AIRWORTHINESS DIRECTIVE

Beechcraft 35 (Bonanza) Series Aeroplanes**AD/BEECH 35/70**
Amdt 1**Airspeed Restriction****1/2003**

Figure 1

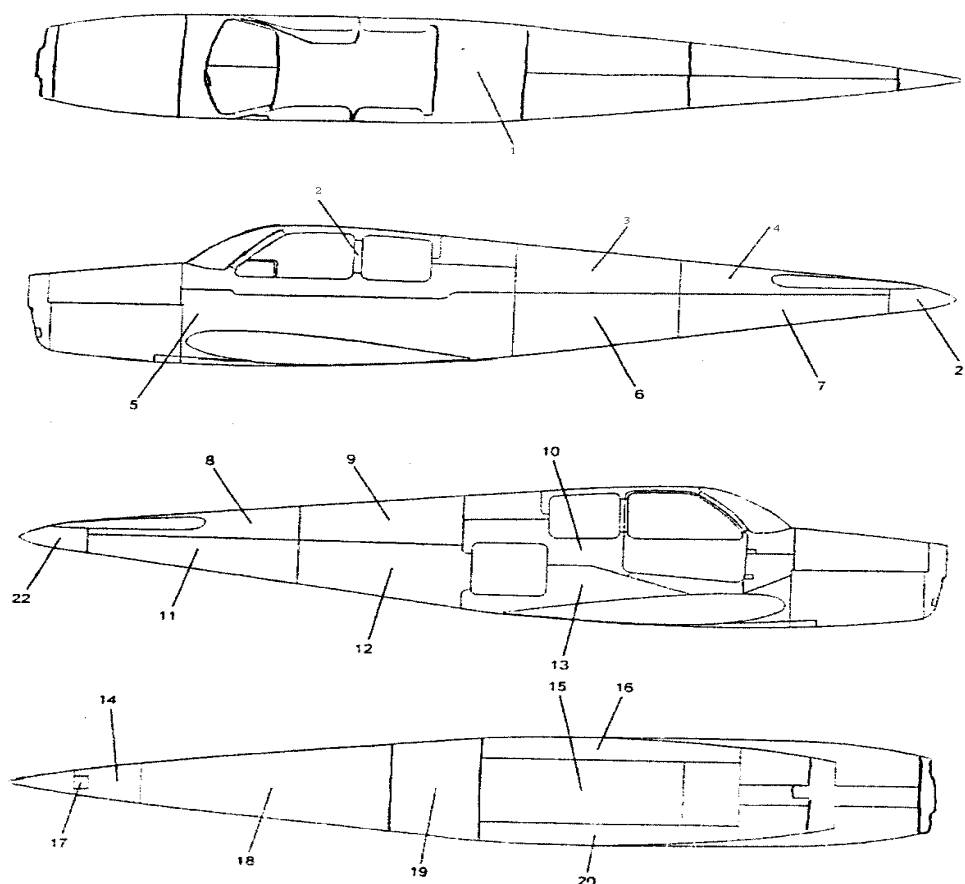
- a. Part of this is an inspection of the aft fuselage skin for wrinkles or cracks. Specific skin thicknesses are presented in Figures 1 and 2 of this Directive. The skin thickness measurement is not repetitive.
